City of Baker School Board
Board Meeting Agenda
Tuesday, June 4, 2024, 6:00 P.M.
School Board Office

**City of Baker School Board Meeting
May 7, 2024**

To: Manning Architects **DATE:** 4/25/2024
FROM: Jason Catlin **QUOTE #:** 077
PROJECT: Baker High School Renovations and Additions
DESCRIPTION OF CHANGES: RFI 160 & 191 Cost for Mods of Ductwork to Fit in Ceiling Space & Added Smoke Damper

CHANGE ORDER INFORMATION:
Change Order Number: 008
Date: 5/30/2024

SHEET NO. **M-1.B1**

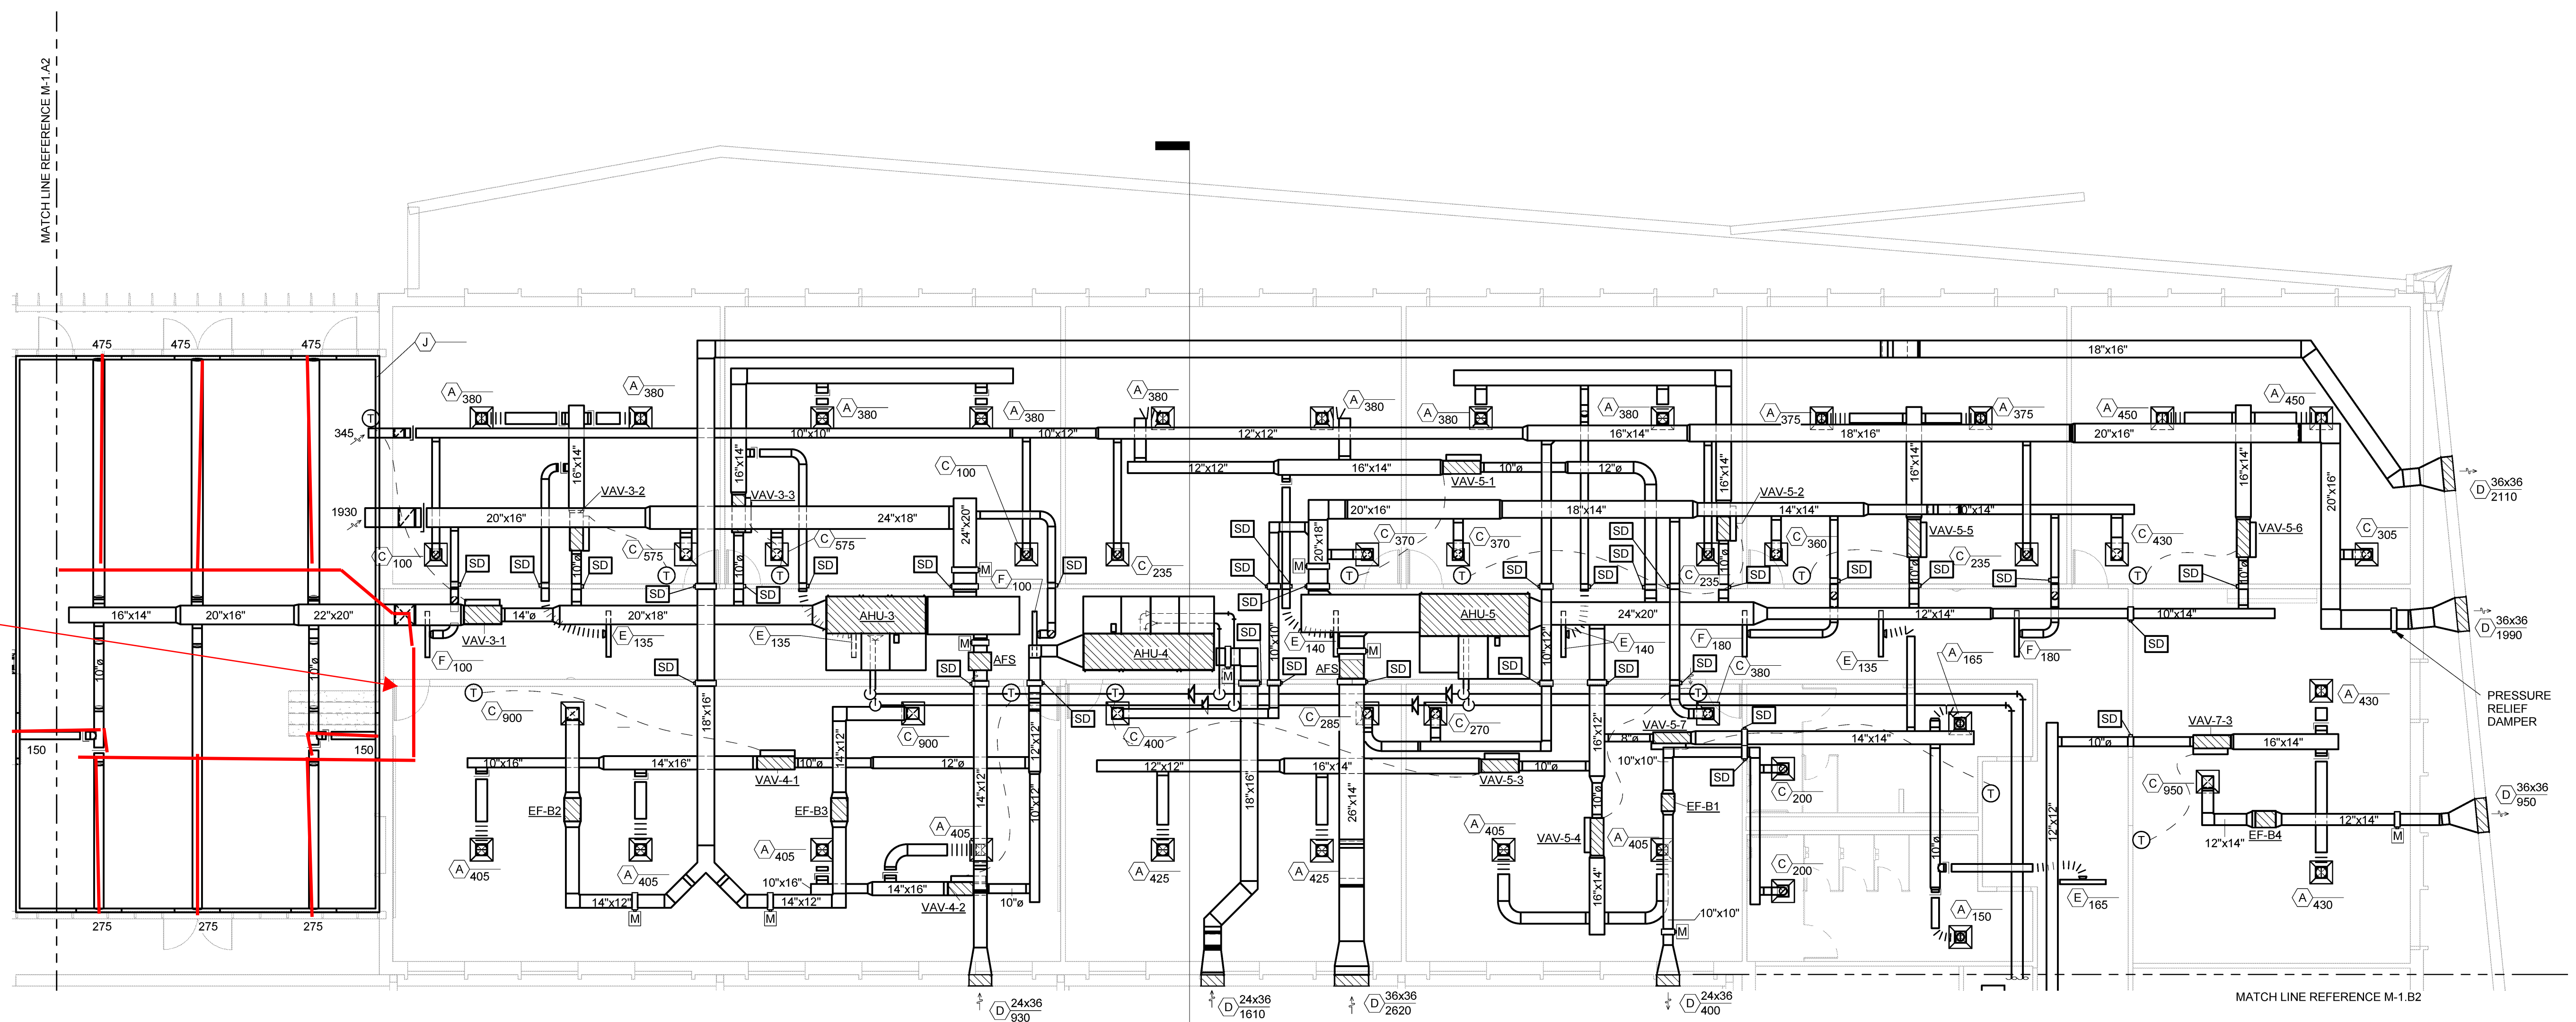
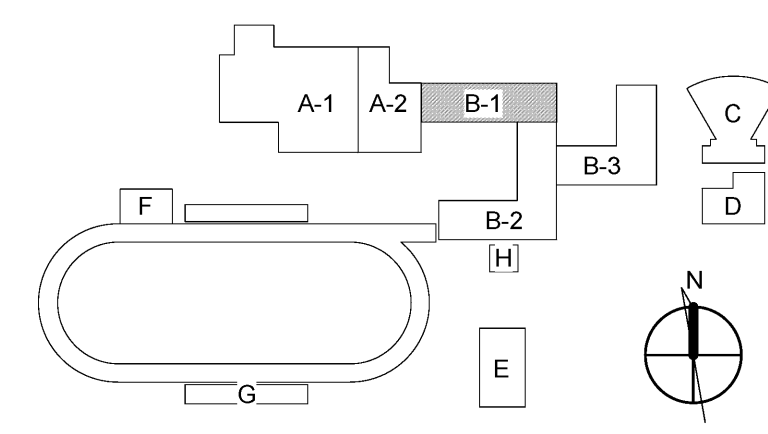
The trunk line in connection is 22x20 decreases to 20x20 then to 16x20 which will still have insulation wrapped around them. These will not fit in the ceiling space and the ceiling grid cannot just be lowered. Please provide revised dimensions for the duct work to allow it to fit in the 16" space.

Split the ductwork before it enters the lobby space and provide two main duct branches in lieu of just one shown on the drawing. One main branch will provide airflow to the three diffusers on the north side of the room; that main duct run should be 14"x18" size. After the first run-off the ductwork can reduce to a 14"x14" size. The second main branch will provide the airflow to the five remaining diffusers near the southside of the room; that main duct run should be 14"x16" size.
